Design Report – Response to Submissions Section 96(2) Modification Application SSD-6013

Car Park Screening

Appendix A – Indicative Finishes Board – Car Park Screen

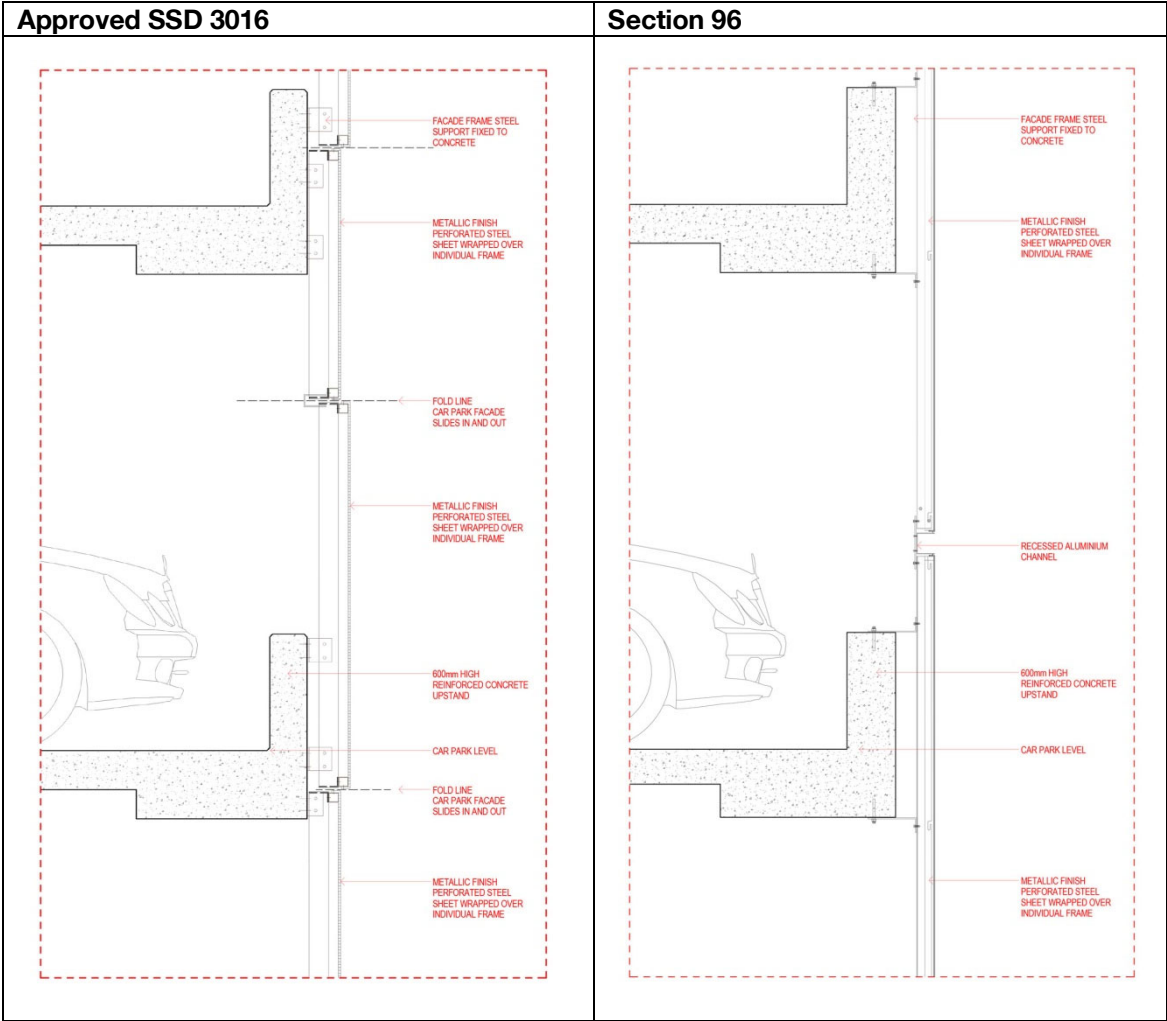
The façade to the car park levels still comprises a composite metal and perforated screen, wrapped over individual frames. The materiality and colours of the façade remain as detailed in the currently approved indicative finishes board (please refer Appendix A).

Appendix B – Perforation Layout

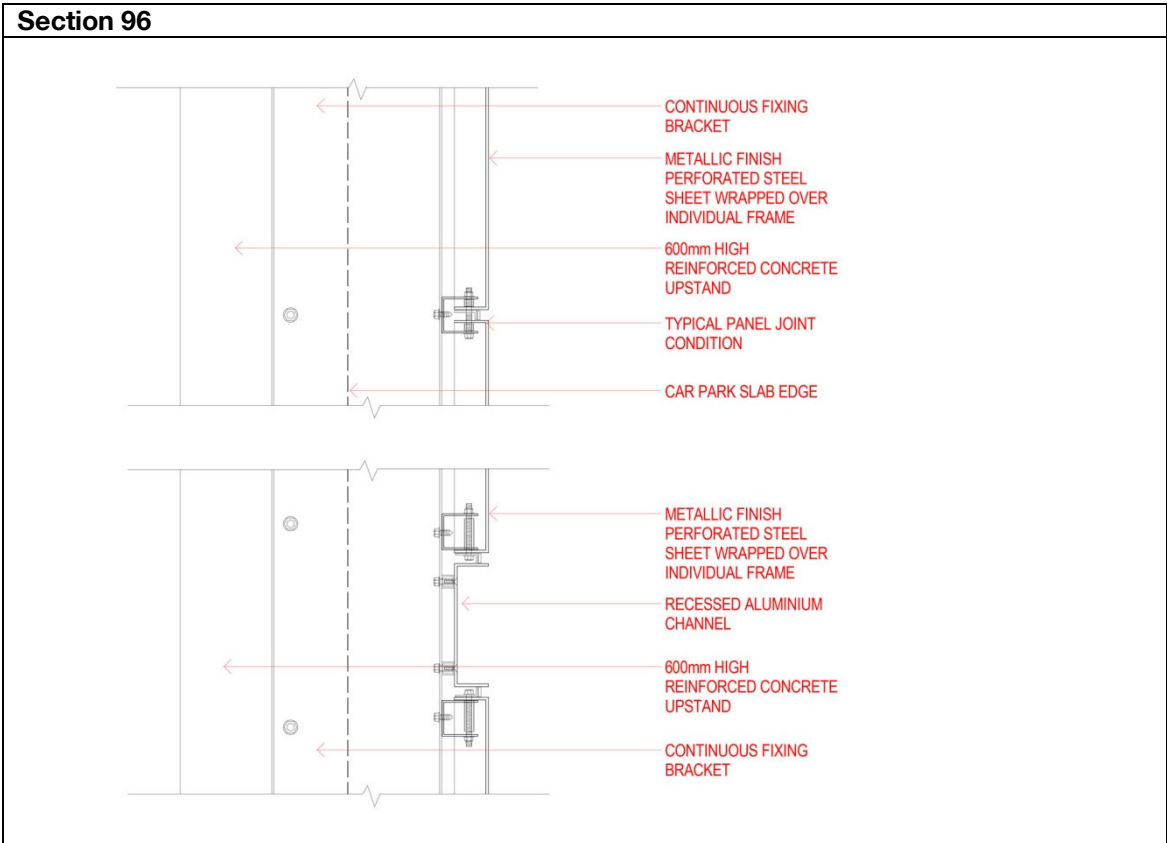
1. The perforation of the façade panels has changed from circular to slotted perforations. As with the currently approved design, the new design will have a combination of varying slot sizes (please refer Appendix B).

The slotted perforations are more in keeping with the design language of the building; being a series of stretched, pulled and elongated surfaces that appear stacked on each other. The orientation of the slotted perforations adds direction to the panels and compliments the horizontality of the design language.

Approved SSD 3016	Section 96
 Approx. 35mm Diameter	 Approx. 50mm x 10mm
 Approx. 20mm Diameter	 Approx. 100mm x 20mm
 Approx. 10mm Diameter	 Approx. 50mm x 10mm

Appendix C – Car Park Cladding - Panel Joints Section

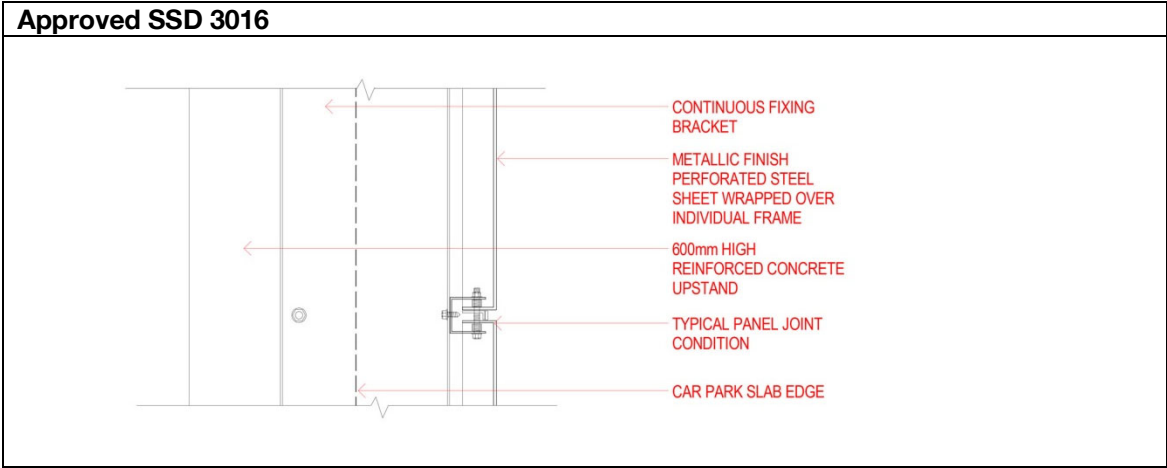
2. The façade panels have been strategically pulled away from each other in specific areas to create interest. At each point where the façade is pulled away, an aluminium channel will be used to provide continuity of the facade screening over the carpark levels (please refer Appendix C). Previously the car park panels slid in and out at certain fold lines.

The concept for the car park cladding is for it to appear stretched and pulled tightly over the mass behind, as opposed to a loosely woven fabric. By placing the panels in one plane, essentially flattening it, also meant that visible openings created by the previously sliding and overlapping arrangement were eliminated. The result is a more precise and defined façade envelope.
